Improved SSPRQ pattern for testing optical transmitters

Piers Dawe

Mellanox

Present and improved SSPRQ

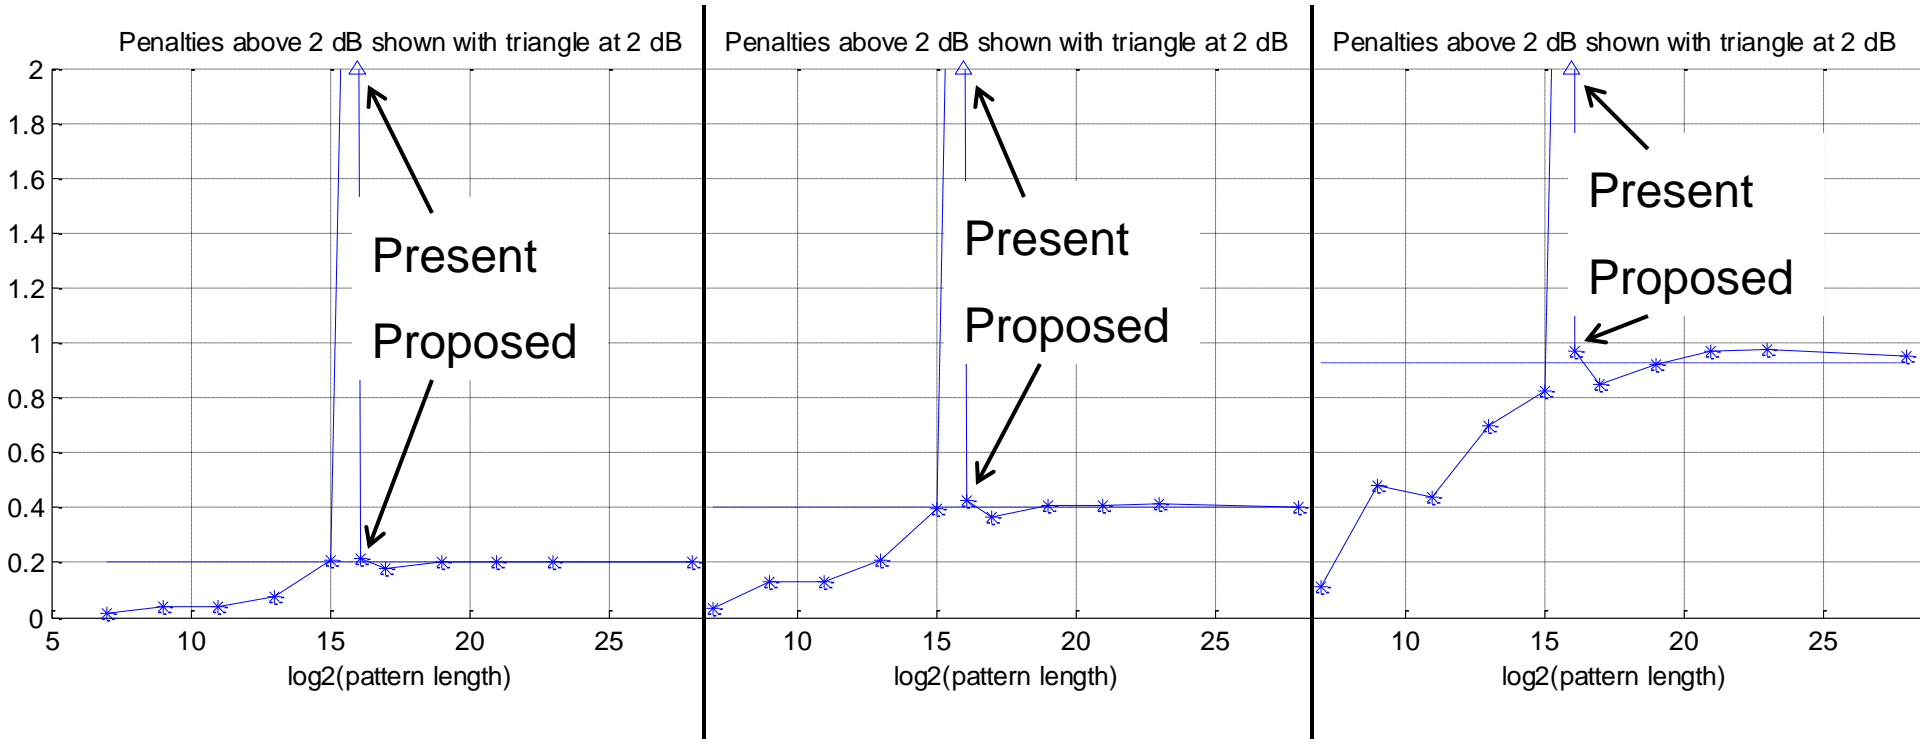
- The first seed in Table 120-2, SSPRQ bit sequence A, was varied until a pattern was found that gave representative penalties
- Modifying SSPRQ like this is a very minor change, both in the draft and in hardware
 - In Table 120-2, SSPRQ bit sequence A, change the first seed from `0x00000002` to `0x022A0ED0`
- Result is shown on next slide
- Pattern is supplied in a separate csv file

- Three cases with different baseline wander penalties
- New point (at 16.1 on x axis) for proposed revised SSPRQ, reports a very slightly high penalty

Improved SSPRQ gives almost the penalty as for random data

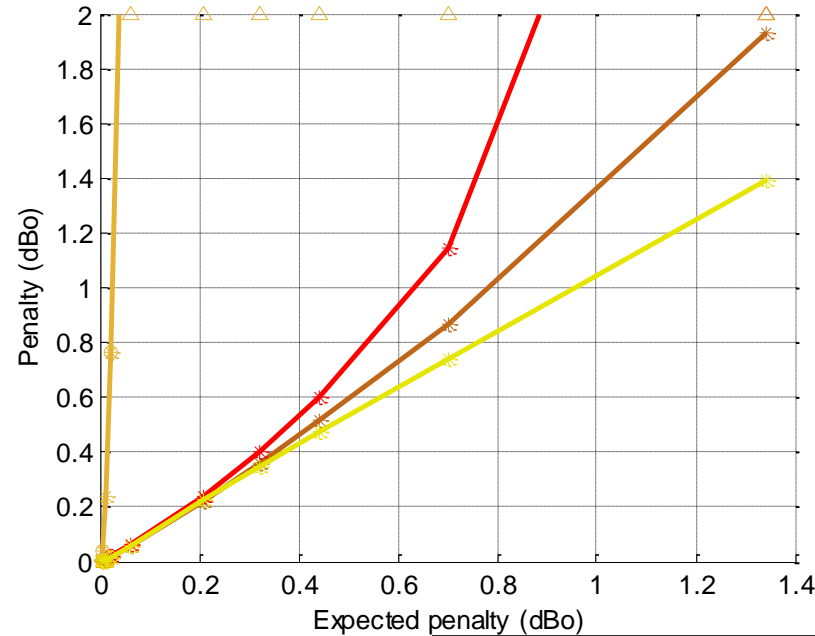
- Brown PRBS15Q
- Red PRBS21Q
- Orange Present SSPRQ
- Yellow Proposed SSPRQ

Yellow is representative: good for SRS calibration

Brown is too challenging

An alternative SSPRQ in between, e.g. similar to the red, could be generated
